REDEVELOPMENT AGENCY FOR THE COUNTY OF RIVERSIDE
RIVERSIDE, CALIFORNIA

CONSTRUCTION DRAWINGS
FOR
COMMUNITY OF HIGHGROVE
CENTER STREET TRUNK SEWER

SEWER IMPROVEMENT PLAN — ACCT. No. W.O. No.
COMMUNITY OF HIGHGROVE CENTER STREET TRUNK SEWER
TITLE SHEET
S-2075
SHEET 1 OF 18

S-2075
SHEET 6 OF 18

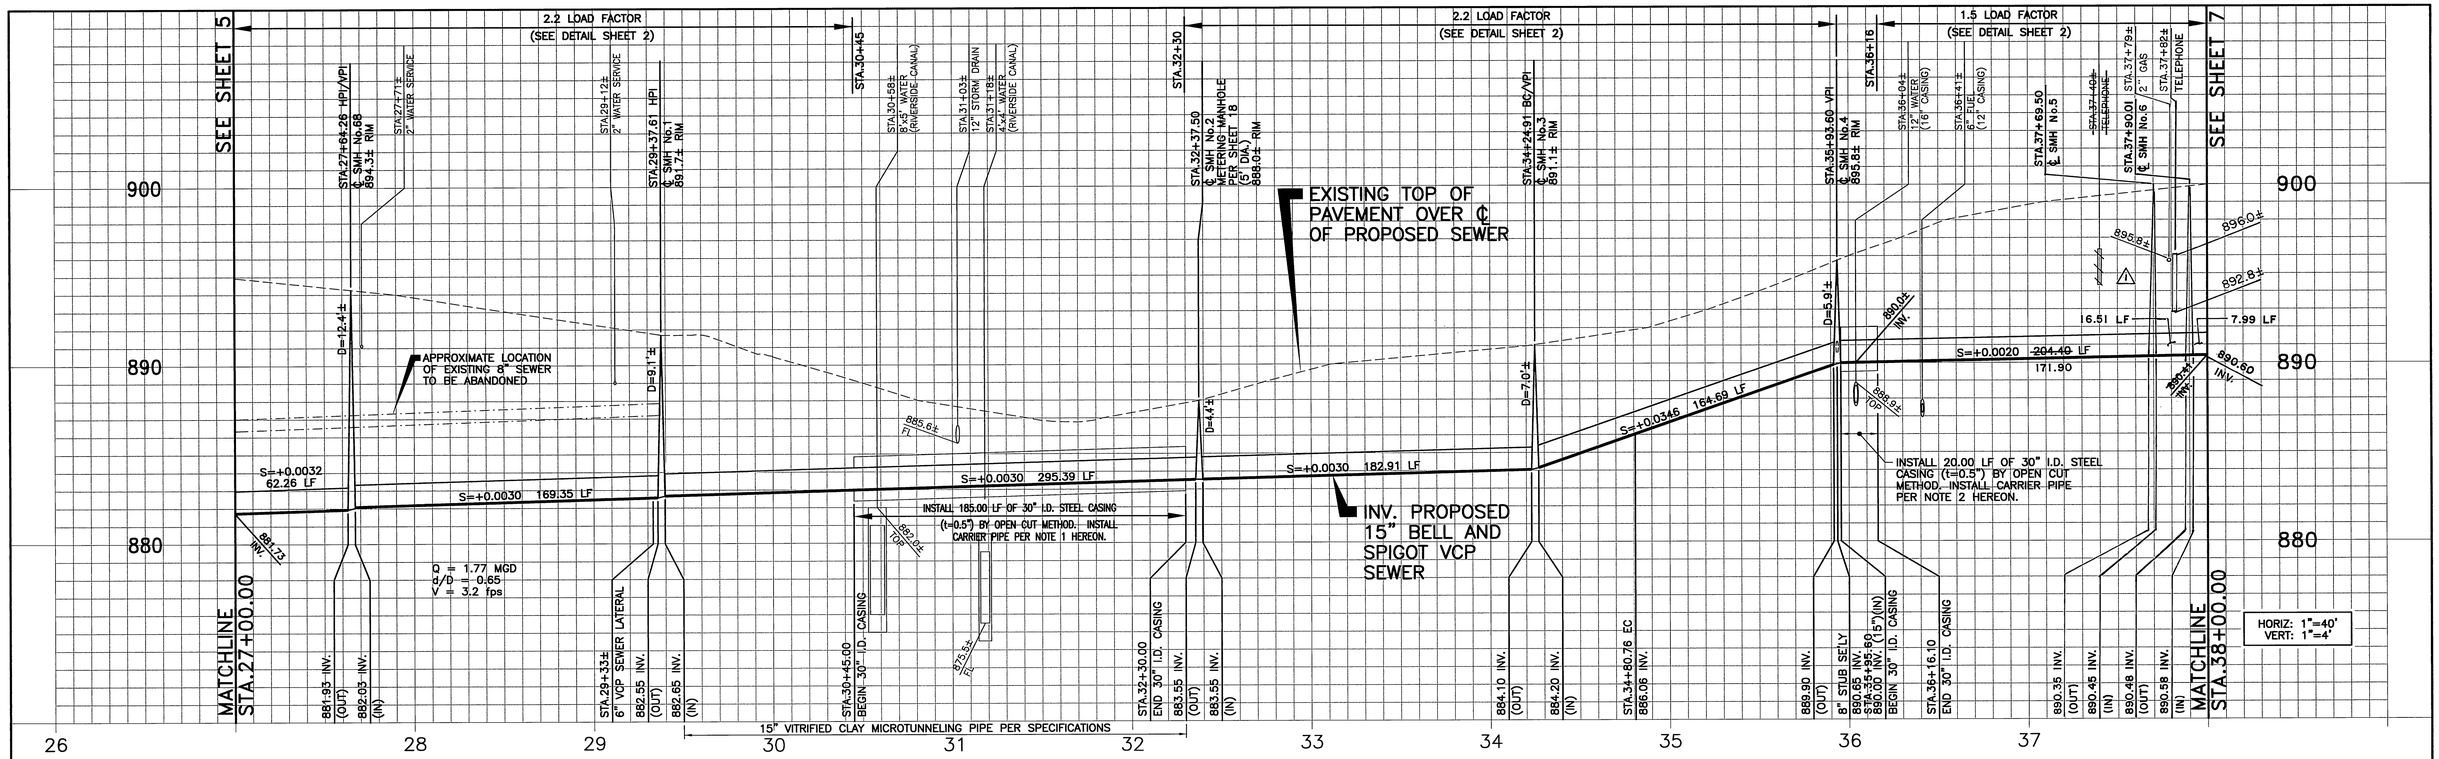
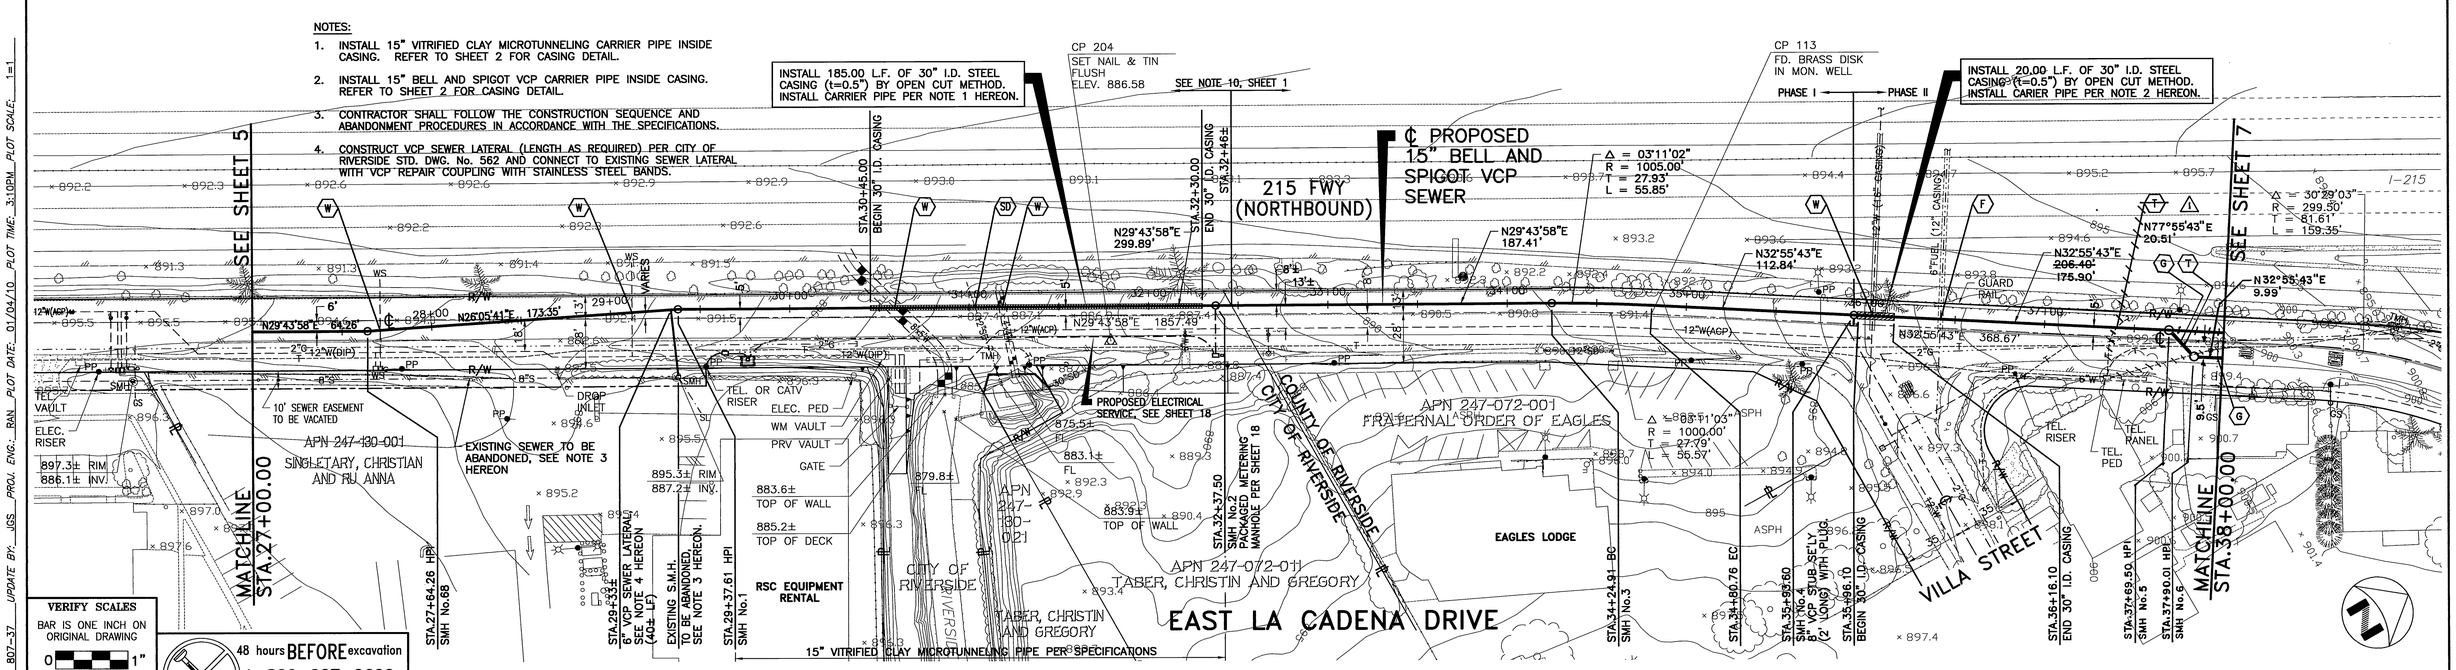
MARK	REVISIONS	APPR.	DATE
1	REVISED SEWER ALIGNMENT AND PROFILE PER CONTRACTOR'S POTHOLE DATA	RAN	1/05/10

SHEET 8 OF 18

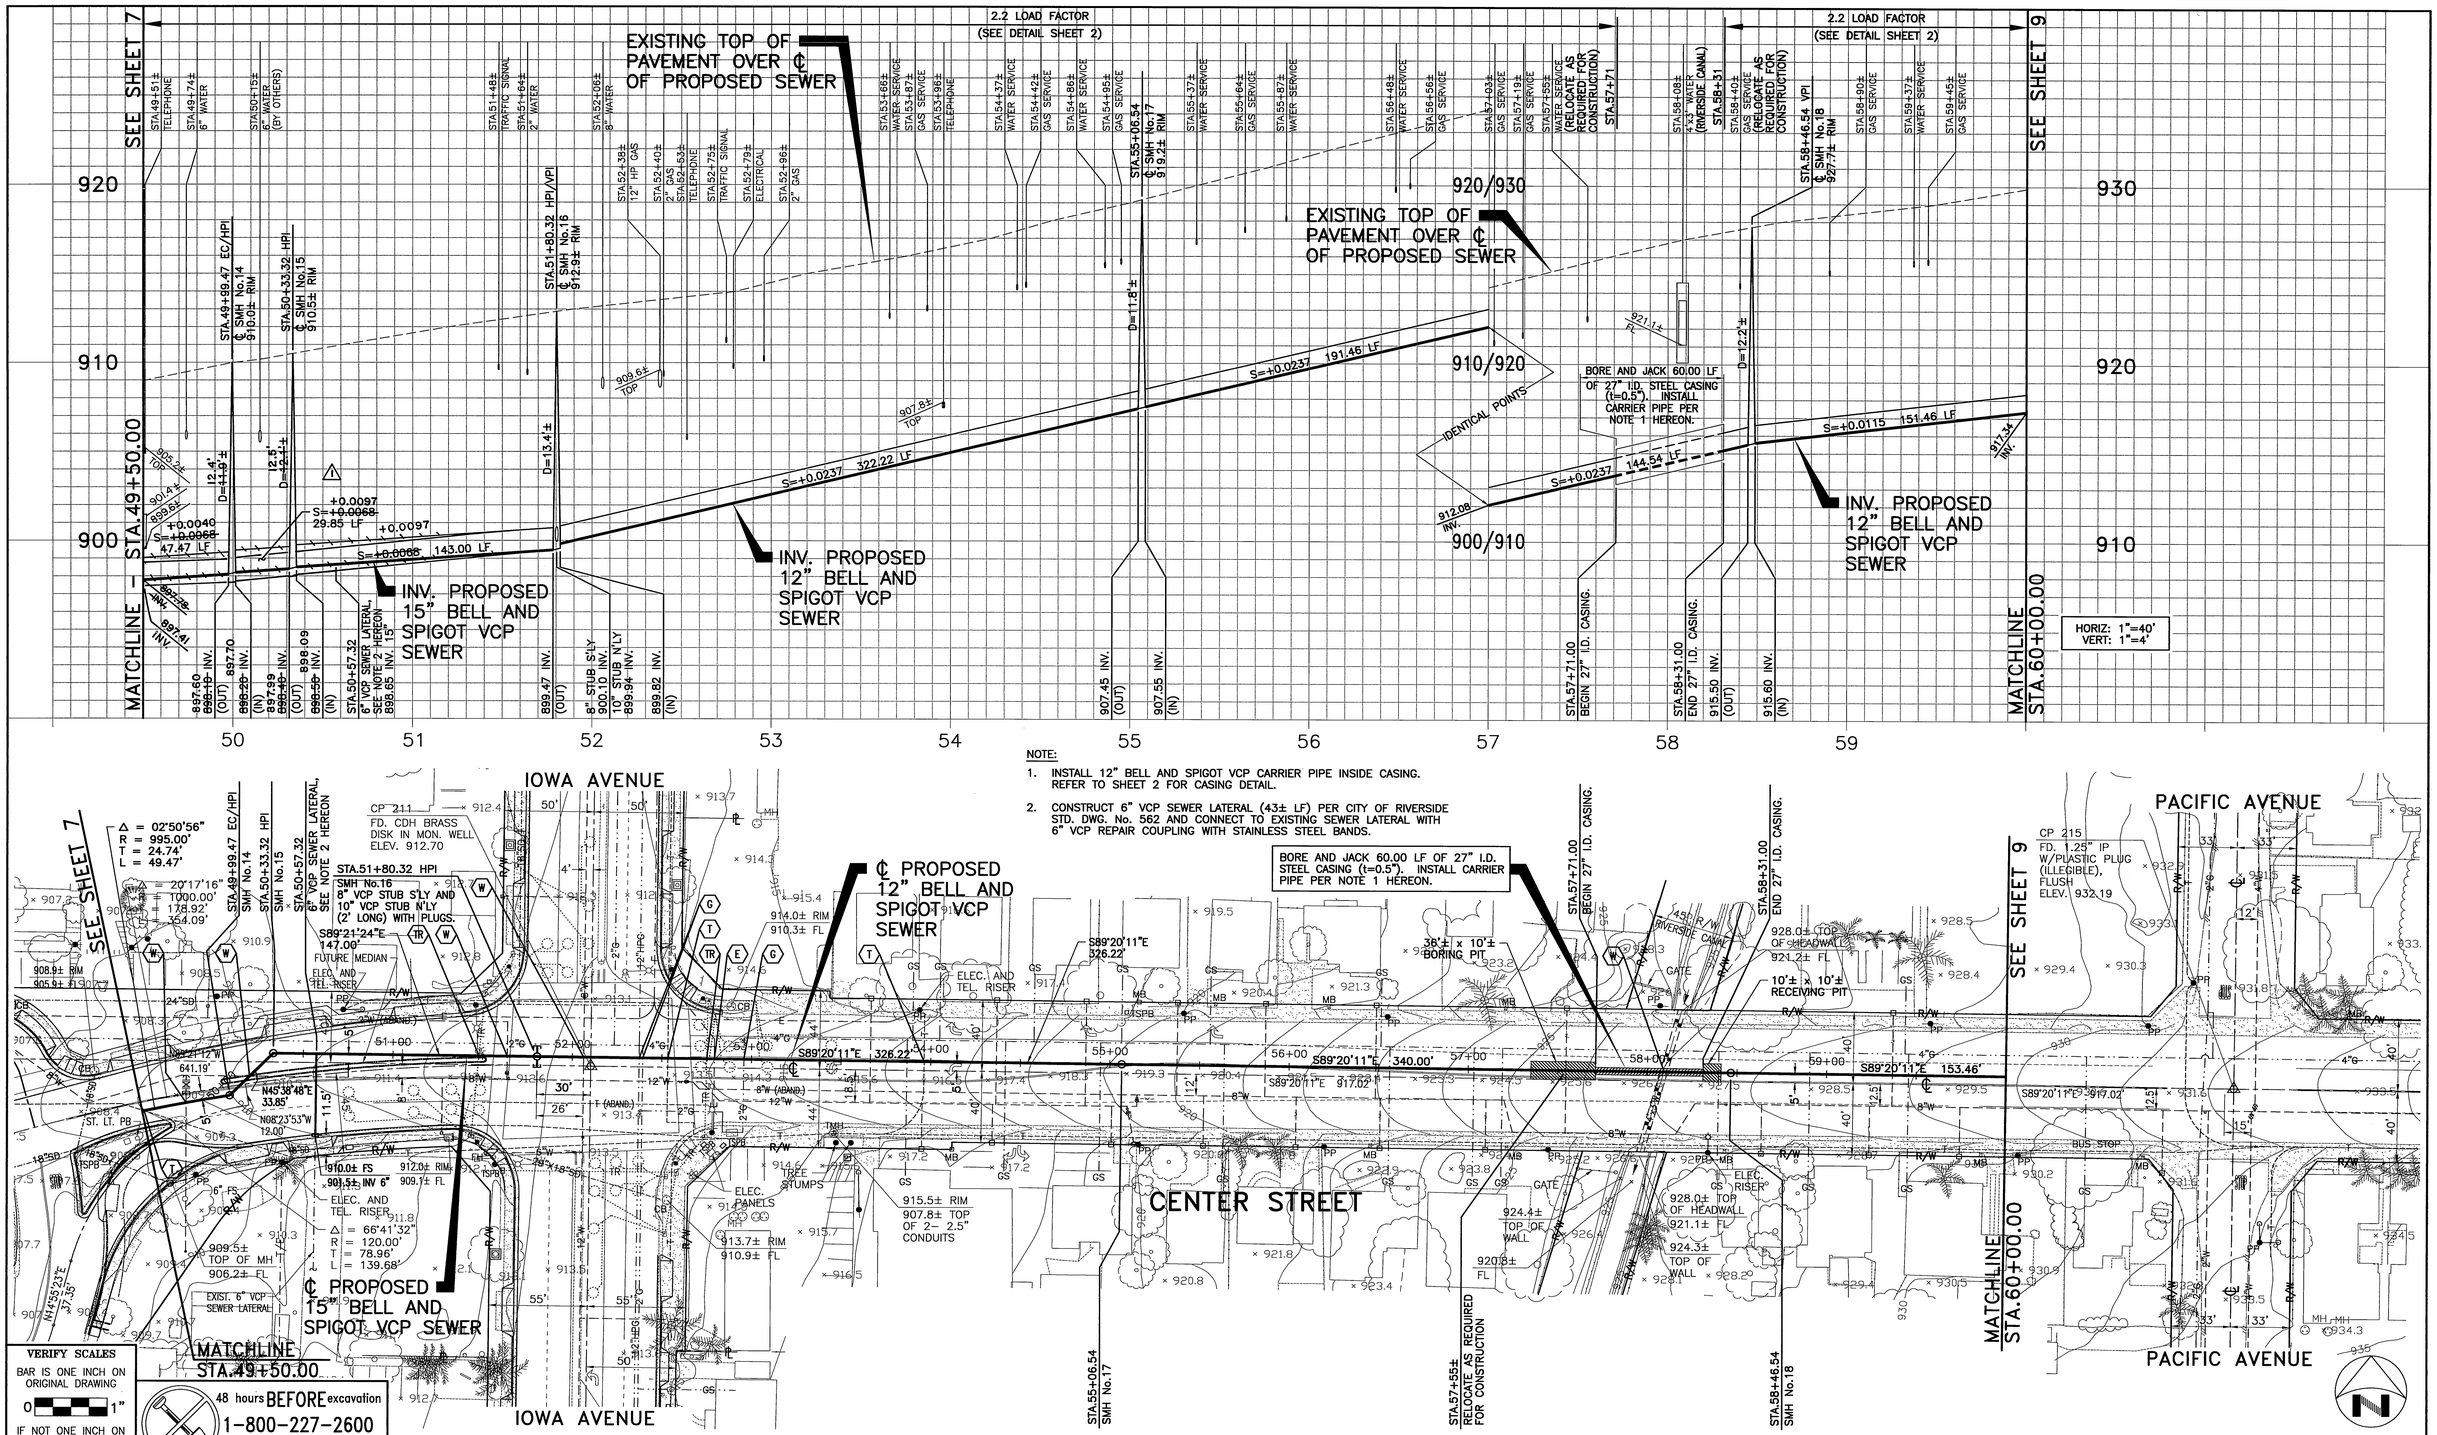
MARK	REVISIONS	APPR.	DATE
1	REVISED SEWER ALIGNMENT AND PROFILE PER CONTRACTOR'S POTHOLE DATA	RAN	01/05/10
